Section 75W Modification (MP 07_0106) Concept Plan Modification

Clemton Park Village (former Sunbeam Factory Site)

Lot 31 (Seniors Housing) Concept Plan Modification

Submitted to Department of Planning and Infrastructure
On Behalf of SDH & Associates c/- Bupa

Figure 1 – Summary of Site Opportunities and Constraints

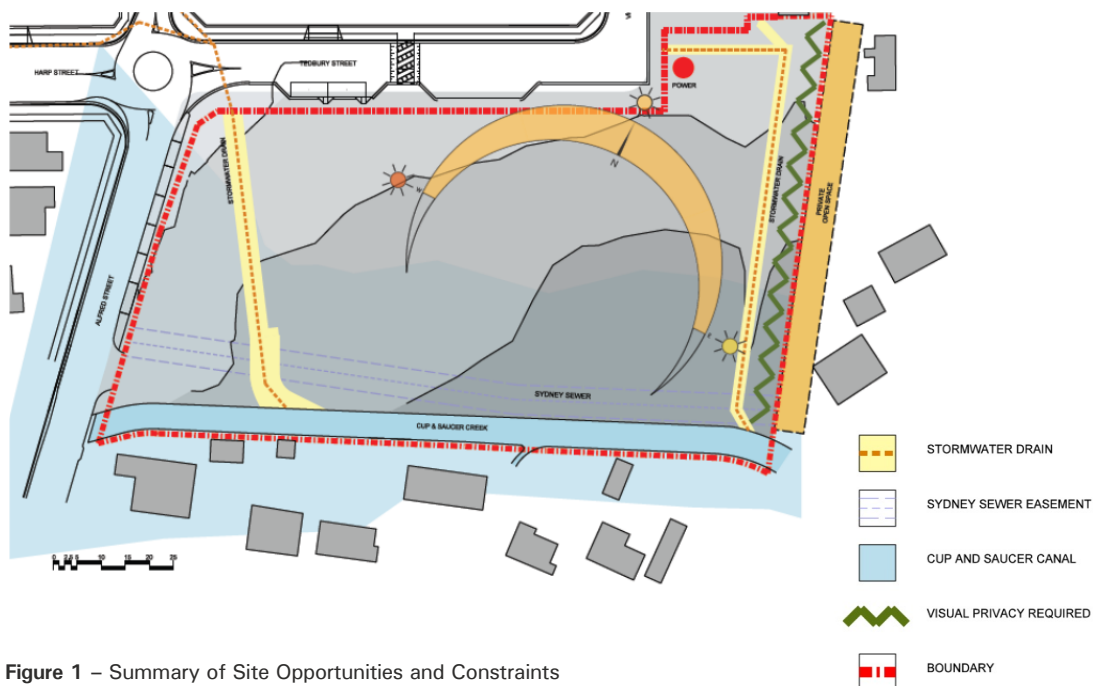
The location of the reconfigured built envelope has been informed by the opportunities and constraints illustrated in **Figure 1** below including the extent of flooding on Lot 31 (discussed in Section 3.3 below), the presence of stormwater drainage easements on the site, the need for visual privacy to Viking Street residents, Council approved vehicular access and traffic management arrangements and the site's orientation.

Figure 2 – Extent of flooding from Cup and Saucer Creek on Lot 31

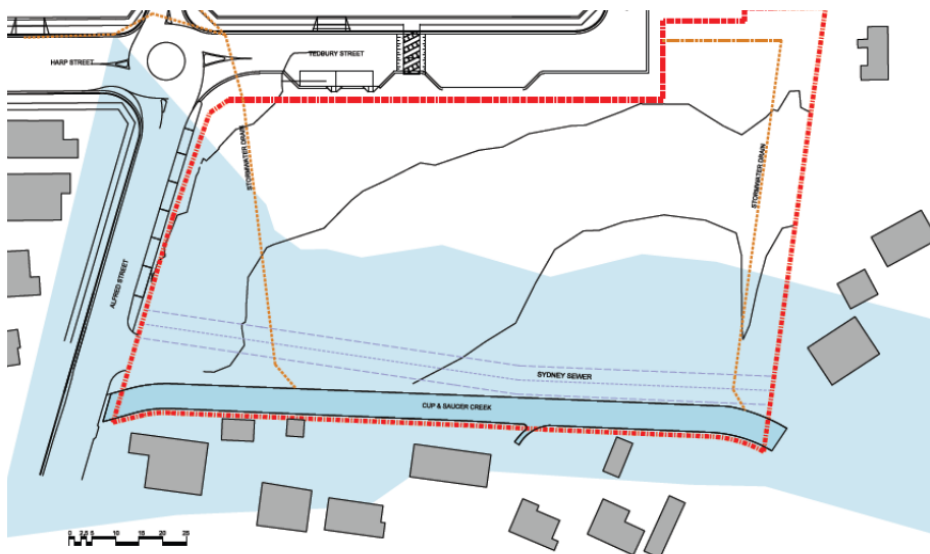
The Concept Plan, as originally approved, recognised that the 100 year ARI flood levels along Cup and Saucer Creek encroach into Proposed Lot 31 extends through the site varying from approximately 22.4m AHD at the upstream of the Alfred Street bridge to approximately 20.6m AHD at the eastern (downstream) side of the site as shown in **Figure 2**.

The proposal has been considered by Craig and Rhodes to ensure that reconfigured building envelope appropriately responds to the flooding constraints on Proposed Lot 31 (**Appendix E**). The Assessment indicates that the Section 75W Modification will not result in any adverse impacts as:

- the lowest habitable floor level of the proposed reconfigured building envelope is 22.90 which is more than 500mm higher than the highest adjacent 100 year flood level at the corner of Alfred Street and Harp Street, and as such the proposed floor level will mitigate any affect to the existing 100 year flood regime;
- compensatory storage will be provided as part of the future Development Application where the reconfigured building envelope encroaches into the existing flood storage volume, and can be achieved through minor re-profiling of the site between Cup and Saucer Creek and the proposed building; and
- the eastern portion of the revised building envelope will be built on columns above the 100 year flood extent to ensure there is no impact on the flood plain.
